SERVICE BULLETIN

BULLETIN NUMBER: 2023-1

SUBJECT: 56919 Dipstick

AFFECTED: 9.5 MCGA, Manufacturing Date Code “WC” (March 2023) and Prior

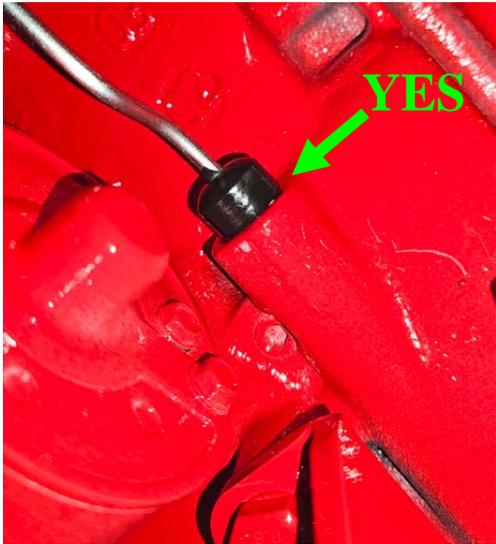
There have been reports from the field of dipsticks on some 9.5 MCGA generators in the subject date codes not fitting as snugly as expected in the engine block. Some of these dipstick seals have been reported to not remain fully seated and potentially weep oil under certain operational and environmental conditions. A revised dipstick grommet has been developed and put into production. The rubber has been reformulated and the dimensions of the grommet have been increased to provide a tighter seal in the engine block. Dipsticks that have shipped from the factory after March 17, 2023 are the latest rev B design. Dipsticks from dealer inventory or shipped from the factory prior to that date may or may not be the latest revision. To determine whether a particular dipstick is the latest revision, measure the grommet diameter as shown below. The measurements shown are with the calipers very lightly in contact with the grommet, not squeezing it. Measure at 2 points 90 degrees from each other and average the result. If there is any uncertainty about which revision a particular dipstick is, replace it with a known new style dipstick.

The improved dipstick design fits very snugly in the engine block to ensure a tight, vibration-resistant seal. Reports from the field indicate that some inexperienced operators might install the new style dipstick incorrectly by failing to insert it fully into the hole. This could potentially result in the dipstick coming out of the hole during engine operation. A brand-new dipstick grommet should be lubricated with engine oil before the first insertion to allow the grommet to slip more easily into the fully seated position. It is important that the dipstick be FULLY and completely inserted into the engine block for proper oil level indication and for optimal sealing. Please refer to the following photographs for more information:
